Research Report 1434

**Human Factors Assessment:
Light Armored Vehicle,
Maintenance/Recovery Vehicle (LAVM/RV)**

December 1986

Figure 12. This is the way equipment is stored.

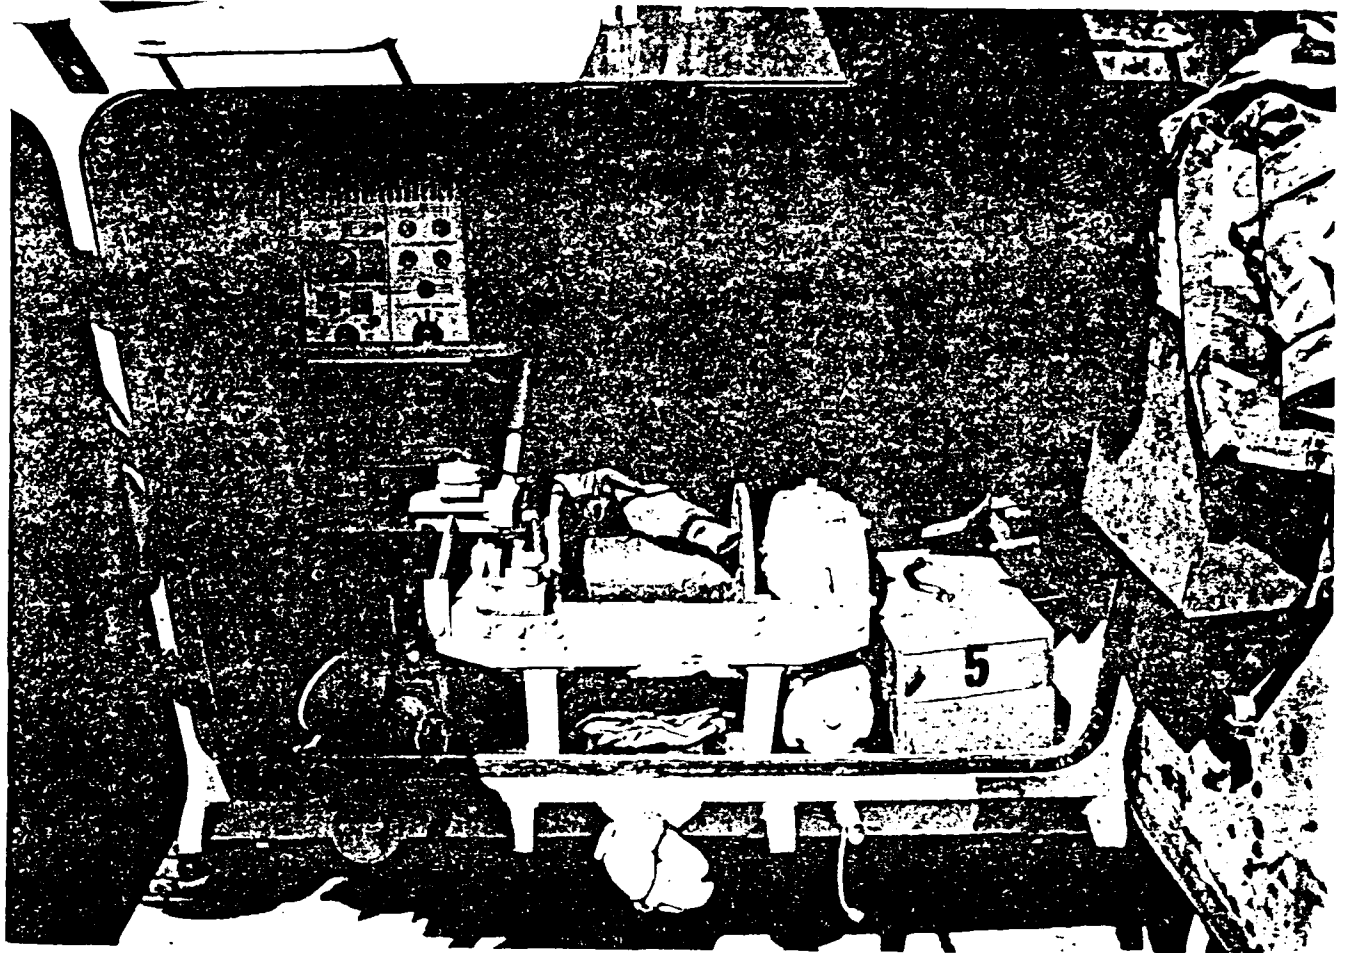
Tool and accessory storage. Crews rated the size and location of storage and the protection of equipment in storage as borderline (average mean rating, 3.1, see questionnaire items 43 to 46). Figure 11 shows the equipment carried in internal vehicle storage locations. Figure 11, however, does not show any combat gear which is also stored inside the vehicle. Figure 12 shows the equipment as it is usually stored in the vehicle. Notice that stored equipment is blocking the passageways. Figure 13 shows two of the three secure storage spaces allocated for all the equipment shown in Figure 11. Secure storage consists of two equipment trays (measuring 26 x 7 x 7 in (66 x 18 x 18 cm)) and one tool box (measuring 19.50 x 13.25 x 10 in (50 x 34 x 25 cm)). The lack of secure storage locations results in the stacking of equipment in any available space. The crew also reported that they stored equipment in their seated legroom and carried equipment in their laps when the vehicle was combat loaded. The lack of secure storage results in several problems, including:

Add secure storage space.

Figure 14. Crew members loading the APU onto its storage rack.

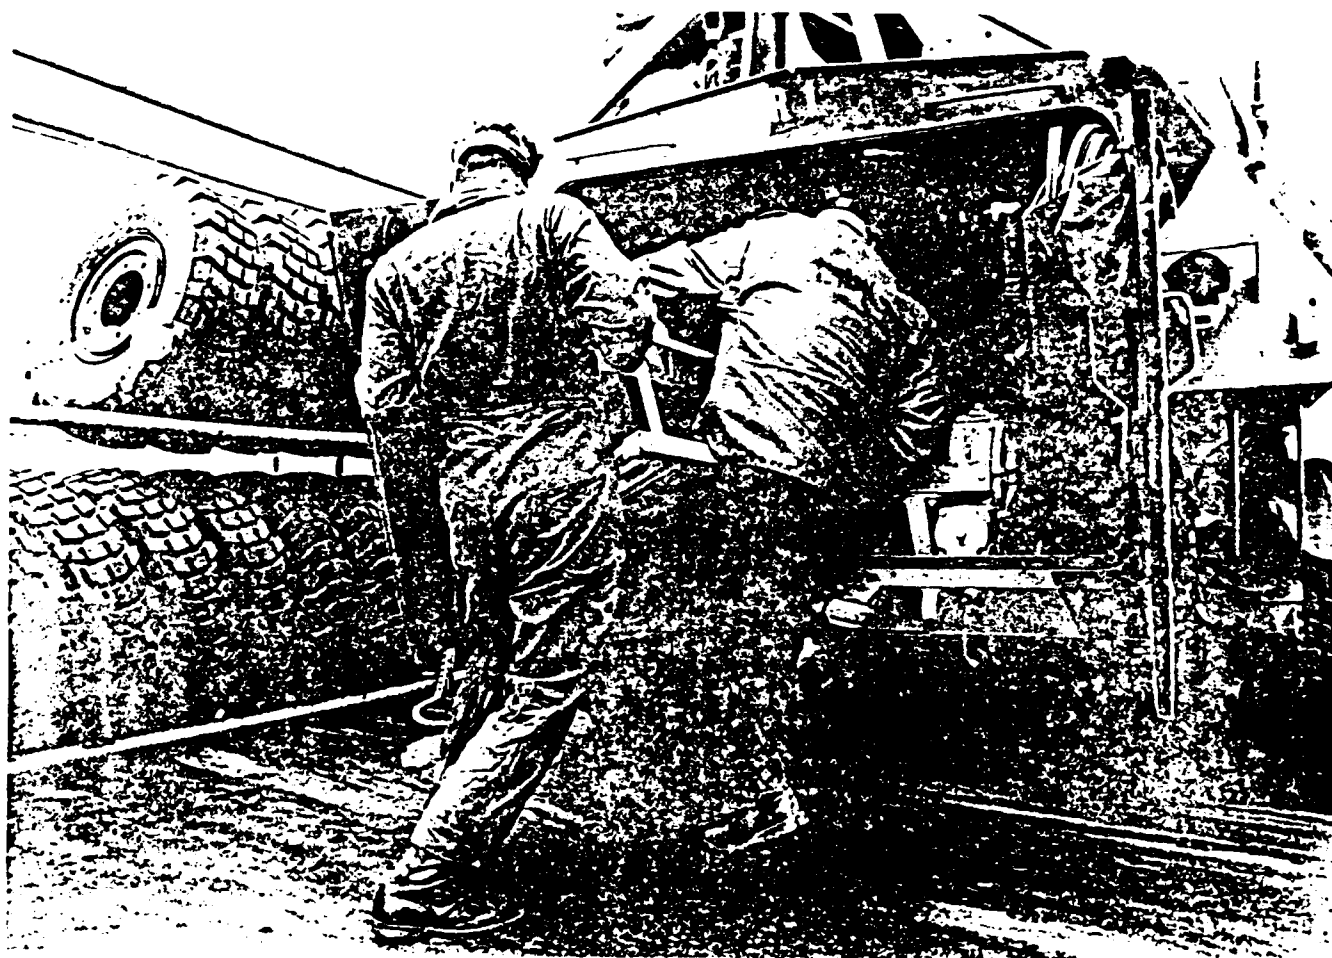
APU storage location. The crews rated the portability of the APU/welder/generator as inadequate (mean rating, 2.5). Moreover, 60 percent of the crews reported that handling the APU was hazardous. Figure 14 shows the crew attempting to load the APU onto the vehicle's storage rack; a procedure which took 15 minutes during each of three separate loading trials. The human factors deficiency results from a combination of the APU's weight (375 lb (170 kg)) and its storage location (APU handrail height to ground is 45 in (114 cm)). Moreover, loading the APU is difficult because its storage rack is alongside the rear wall of the vehicle and access to the rack from the left side is completely blocked by the left rear door. During the loading of the APU, only two to three crew members can position themselves to lift and align the APU to its storage rack (lifting weight per person is 187.5 to 125 lb (85.05 to 56.70 kg)). MIL-STD-1472C limits the weight to 50 lb (3 kg) for a height of 48 in (127 cm). This human factors deficiency is likely to result in:

1. Injury to the crew,
2. Equipment damage to the APU or storage rack,
3. Abandonment of the APU during an emergency.

Design changes might include repositioning the APU to allow more of the crew to participate in lifting the device. However, even if all five crew members lift the APU, the lifted weight per person is 75 lb (34 kg) and violates the MIL standard. A better solution might be to add a sliding carriage rack to the APU storage rack that slides out and locks in place beyond the rear door opening. It would then be possible to load the

APU onto the carriage rack using the crane and some type of attachment device. Should this solution be implemented, the APU attachment device should be permanently attached to the APU to avoid its loss.

Figure 16. The workbench.

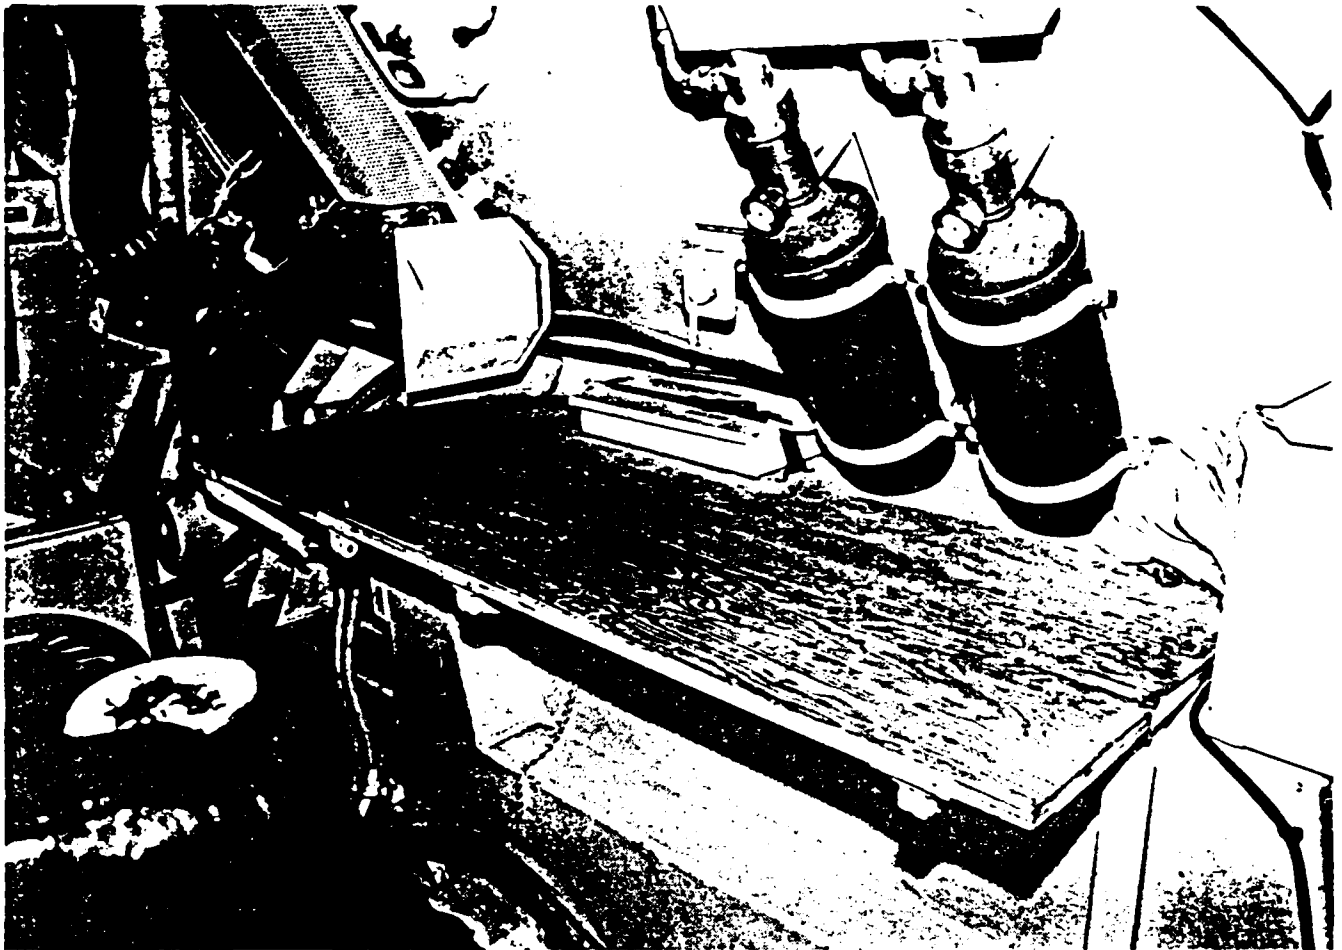
Workbench. The crews rated the usefulness of the workbench as borderline (mean rating, 3.0). Moreover, many workbench features were rated as inadequate, including legroom when seated (mean rating, 2.1), seating position (mean rating, 2.5), and overall comfort when seated (mean rating, 2.5). Figure 16 shows the workbench unfolded (46.75 x 20 in (118.75 x 51 cm)). In interviews, crew members felt that the workbench would not be used. Crew members could not envision performing repair work on small components; the only type of work that could be performed at the workbench. This is because most field maintenance involves the removal and replacement of the entire component. Moreover, crew members stated that the lack of legroom made sitting at the workbench very uncomfortable and difficult to leave the seat for needed tools (seat to wall width 12 in (30 cm); workbench to floor height, 24 in (61 cm)). Thus, they preferred to work outside of the vehicle. Removing the workbench from the vehicle would provide additional legroom and storage space for personal gear.

Figure 18. The hydraulic hoses of the winch drive motor are unprotected and are tripping hazards.

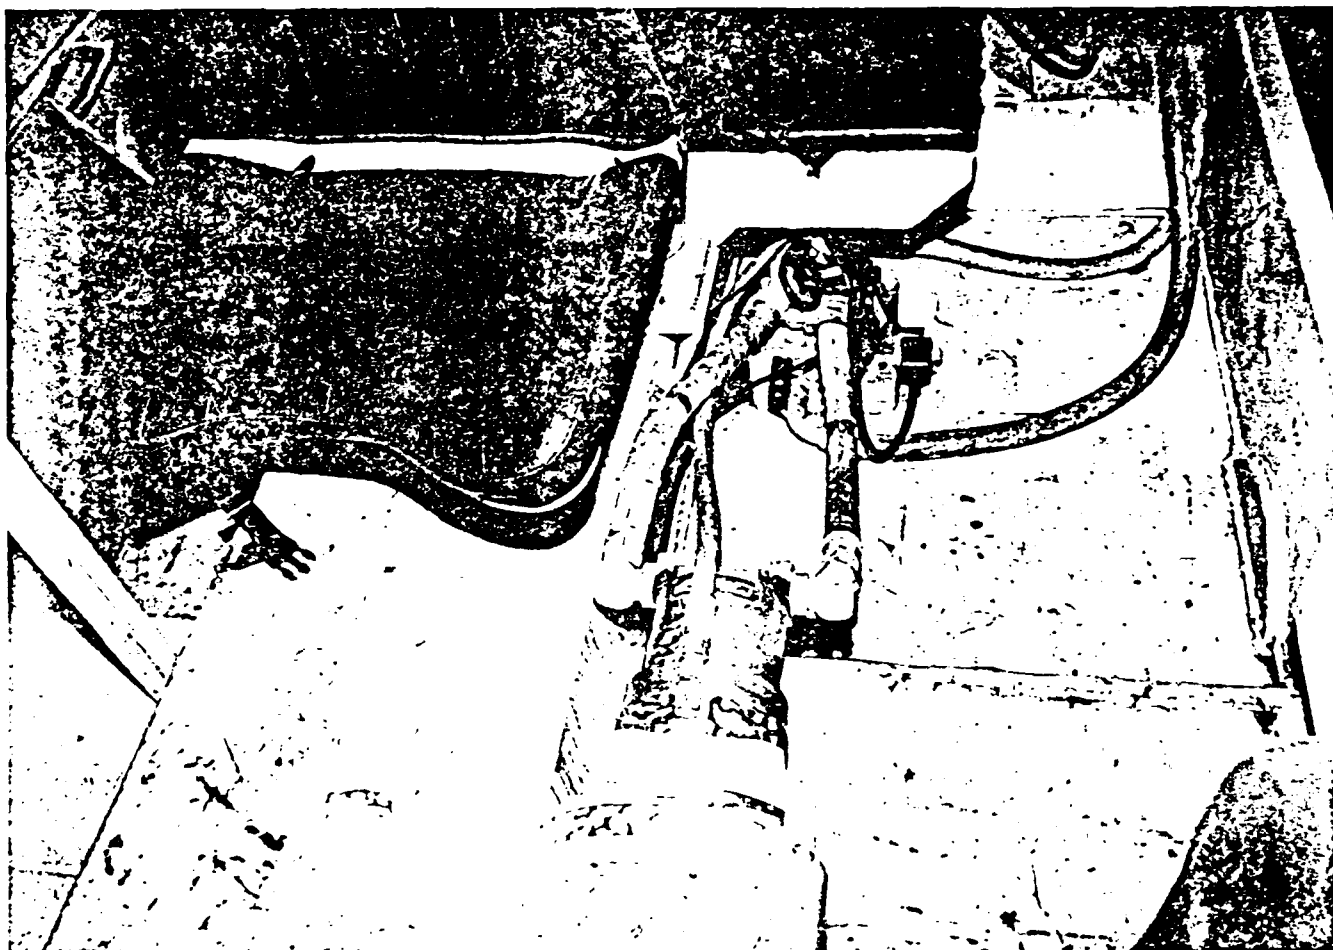
Hydraulic hoses. Two crew members reported that their feet had become entangled in hydraulic hoses. Figure 18 shows the winch drive motor and hydraulic hose assembly next to the rigger's seat. Hoses that are unprotected in passageways are a tripping hazard. Moreover, the service life of the hoses and fittings are reduced when they are continually bumped and abraded. The winch drive motor hydraulic hoses should be protected.

<u>Workspace (cont'd)</u>	<u>Illumination</u>
Cover winch drive motor hydraulic hoses.	Add blue lights over bilge pump.
Provide room to don MOPP clothing.	<u>Visual Coverage</u>
Lengthen fuel transfer hoses.	Move rear view mirrors closer to driver.
Guard amphibious propellers.	
<u>Communications</u>	<u>Operator Manuals</u>
Add a 20 ft (6.1m) CVC spaghetti cord and a CVC jack at the rear doors.	Add information describing all equipment applications.
<u>Design For Maintenance</u>	Add information on unique recovery techniques using LAVM/RV equipment.
Simplify power pack access panel latches.	Add information about rigging force and weight calculations.
Provide space to access transfer case doghouse.	<u>Operator Training Needs</u>
Provide additional tools and NBC decontamination equipment.	Determining rigging force and weight calculations.
Lengthen PTO manifold hoses.	Determining appropriate use for winch and crane.

Figure 19. The amphibious propeller extends beyond the sponson and wheel.

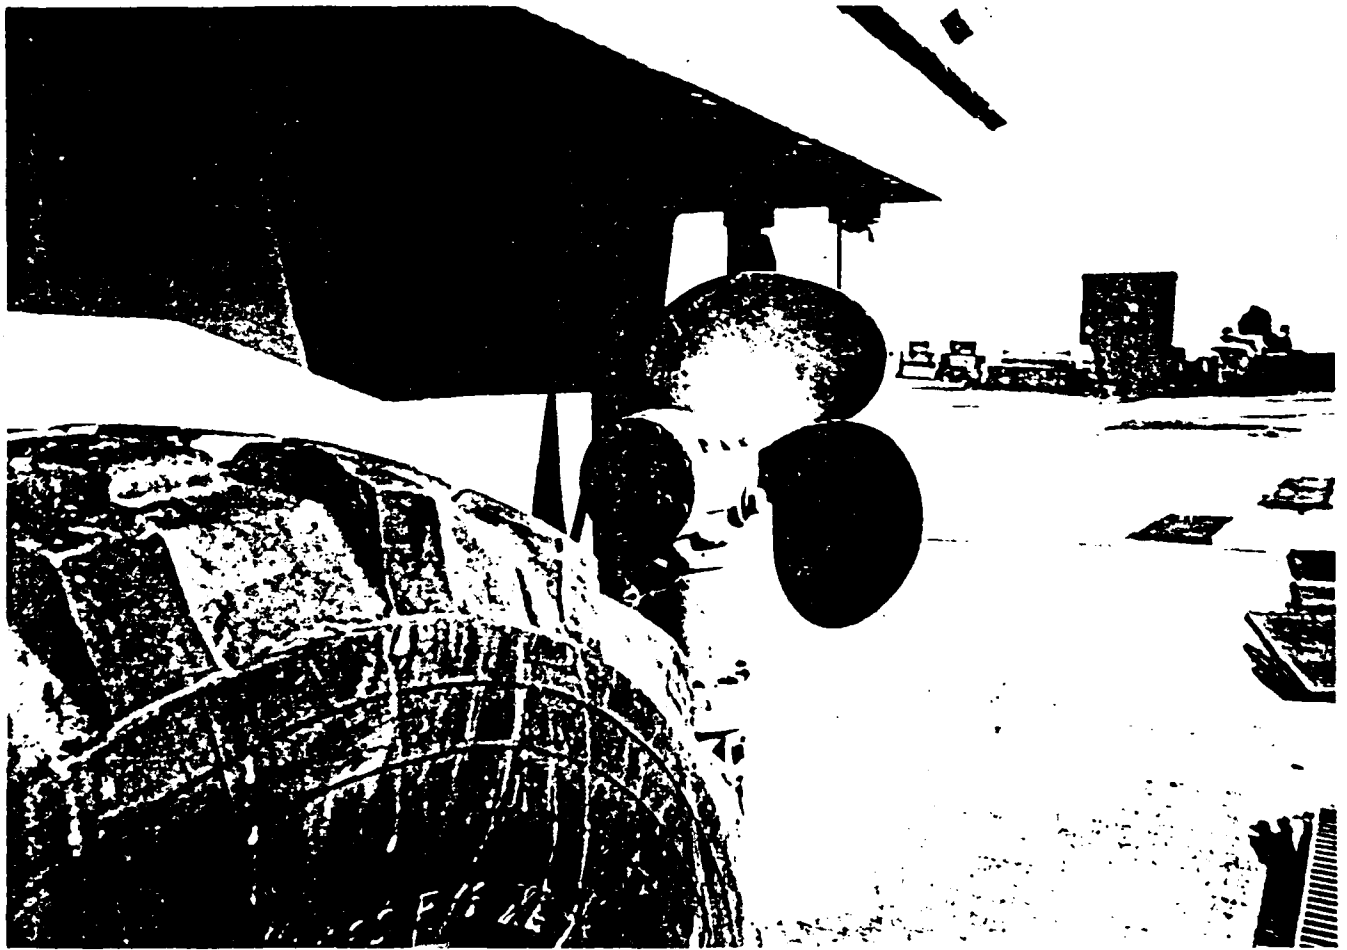
Amphibious propellers. Figure 19 shows one of the propellers at the rear of the vehicle that are used for amphibious operation. The propellers are unguarded and extend 1 in (2.5 cm) beyond the edge of the sponson and 2 in (5 cm) beyond the outer edge of the rear wheel. The propellers are likely to be out of the sight of personnel walking around the corner of the vehicle from the rear. Moreover, the large open space surrounding the propellers increases the chance that objects might collide with the blades when they are spinning. It is in close quarters, such as on naval ships, that the propellers might be engaged while personnel are in the area. The propeller blades should be guarded.
